**RE: FURTHER ISSUES RESPONSE: TRAFFIC AND TRANSPORT ITEMS
PROPOSED CHANGE APPLICATION AT 43-77 OLD PUB LANE, GREENBANK**

Approval no: DEV2019/1035/2

Our ref: DEV2019/1035/2

Figure 3.1: Temporal Parking Demands (Weekday)

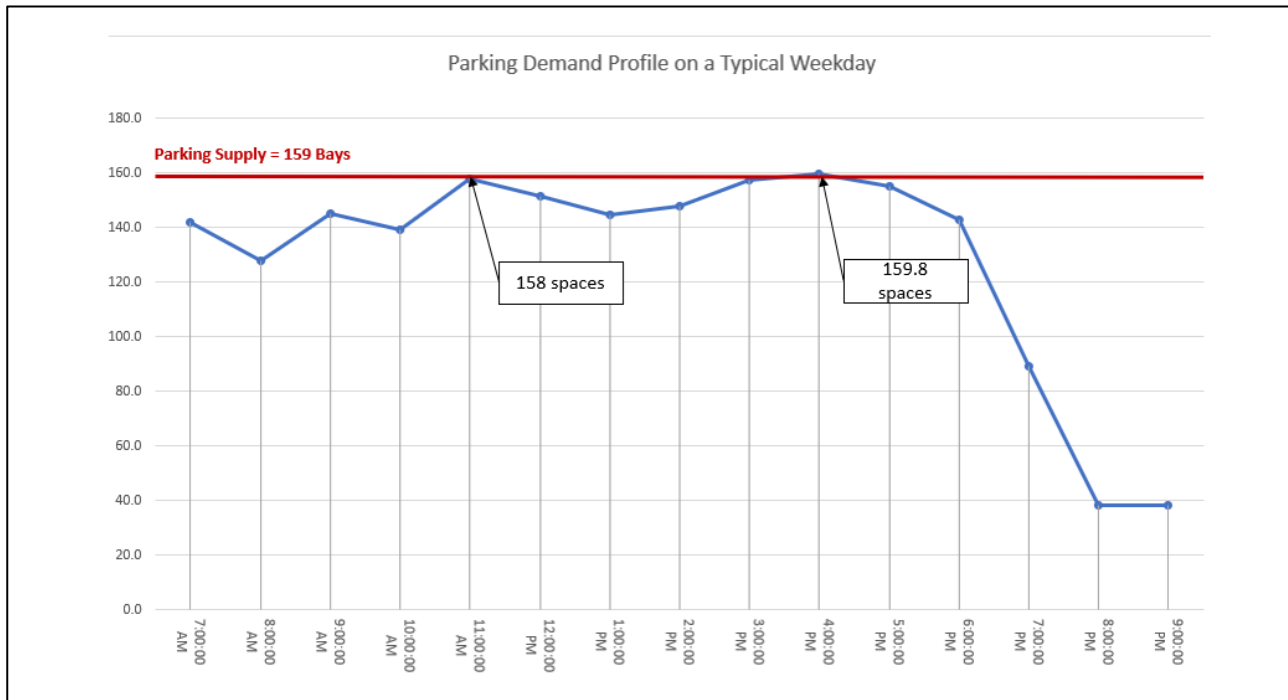
1. The Trip Generation Surveys in the RMS are all NSW specific and do not correlate to the outcomes that are occurring in Logan. For instance, some of the areas used to determine trip generation rates include Bondi and Kings Cross, which are heavily orientated to PT services. This is quite different from this location where there is only 1 PT service that could service this site and this PT Service does not currently service the potential customer base for these uses, i.e. Everleigh and Covella.

2. The Traffic report further states that from the Trip Generation Surveys we can apply a Temporal Parking Demand to further reduce the car parking rates. EDQ has applied a practice in the other PDA's where if multi uses are provided and a relaxation is sought to the car parking rates, we would utilise the Logan Planning Scheme less either the temporal parking rates, or just the rates identified in the Trip Generation Survey that has been identified using relevant local examples.

EDQ raised concerns in the Response Email dated 16th June 2021 regarding the use of reduced rates and temporal analysis to determine the parking demand of the site. Whilst this methodology is still considered appropriate, to address EDQ's concerns a revised assessment has been conducted considering parking rates in accordance with Council's requirements and considering the temporal demand nature of the proposed uses (i.e. varying parking demands per use across a typical day).

As shown, the peak parking demand for all three (3) lots will be at 4:00pm on a weekday with a peak parking demand of 160 spaces. Detailed temporal demand analysis are provided at **Attachment 4**.

Lot 2 HRV In & Out Swept Paths

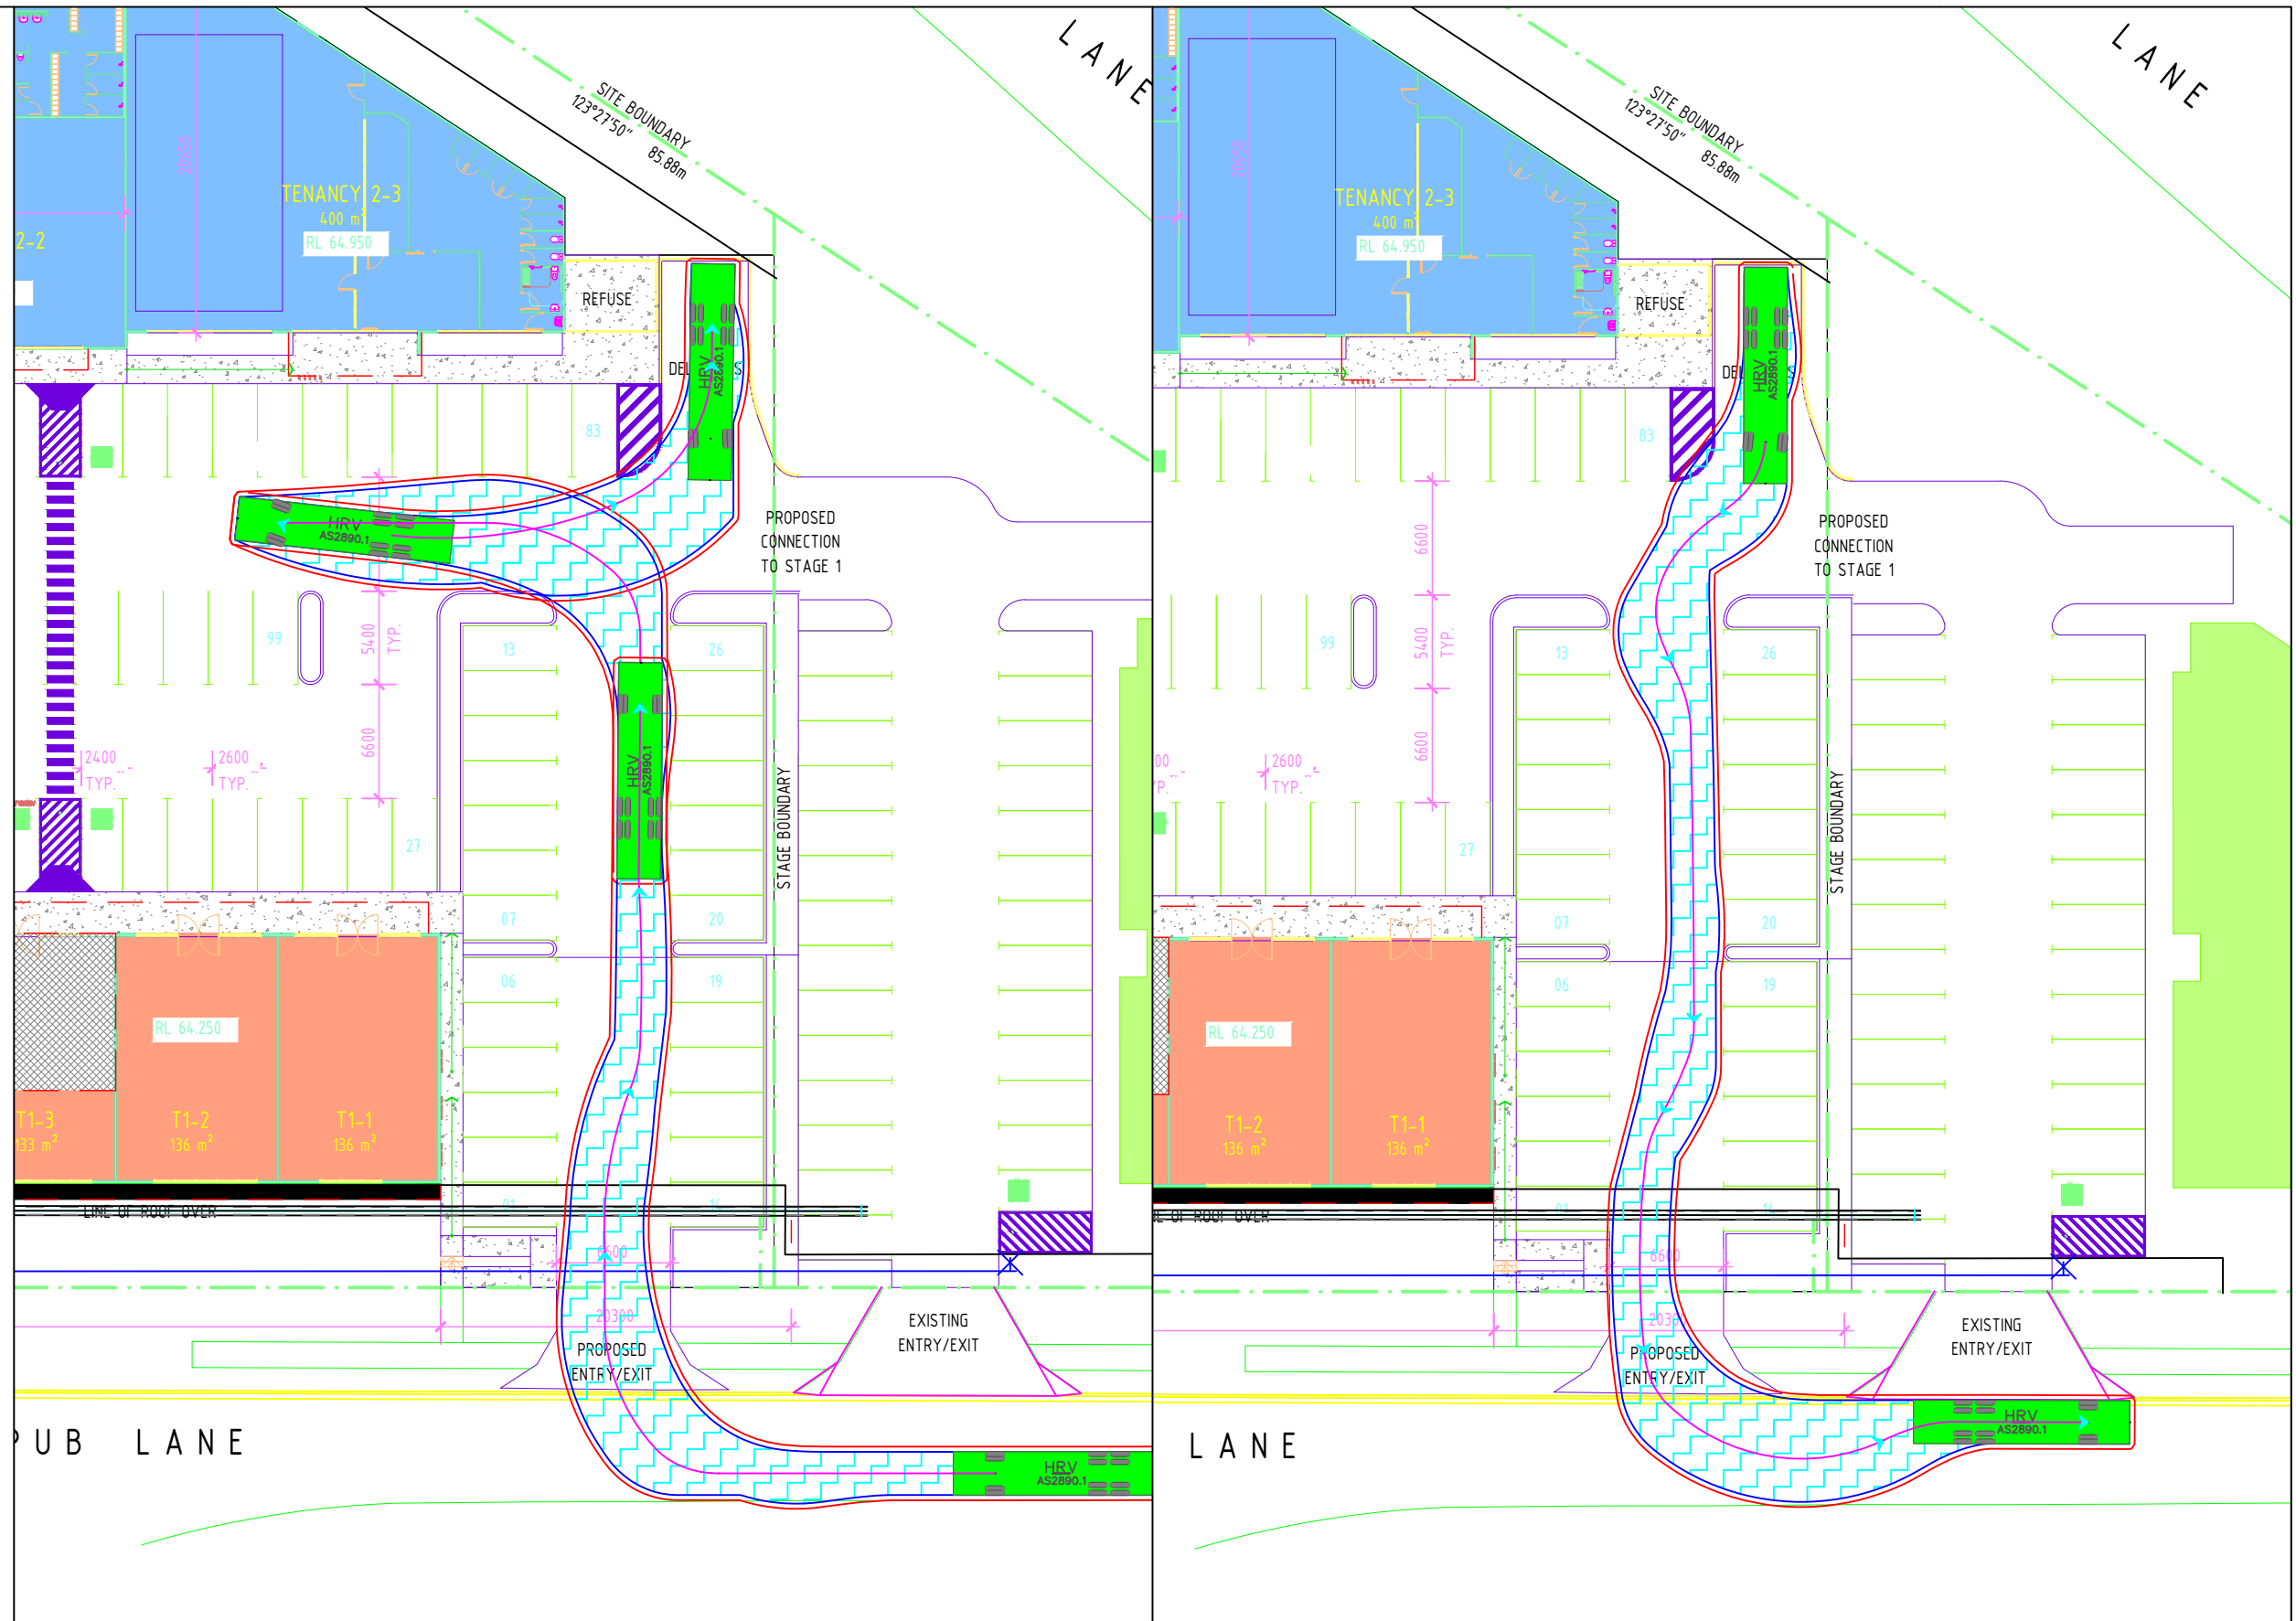
2. Submit a Traffic Engineering report/memo assessing the suitability of the new layout for the service/refuse vehicles movements for each of the Lots, and assessing the suitability of the new proposed driveway access for Lot 2, including amenity impacts (noise, light intrusion into the dwellings) of vehicles existing from the new driveway for residents opposite the new driveway location.

Lot 2 Servicing

Consistent with the Masterplan Approval, a shared servicing bay (12.5m x 5m) that can accommodate service vehicles up to the size of HRV has been proposed for Lot 2. The provision of a single bay is expected to be adequate to service Lot 2, noting that the proposed uses (Indoor Sport and Recreation and Medical Centre) will be serviced occasionally only. Furthermore, a footpath connecting Building 1 to the loading bay has been provided.

Relevant swept path diagrams have been prepared which demonstrate that Lot 2 can be serviced by an RCV independently. This includes entry and exit in a forward gear and access to the proposed loading bay. Swept path diagrams are included in **Attachment 3**.
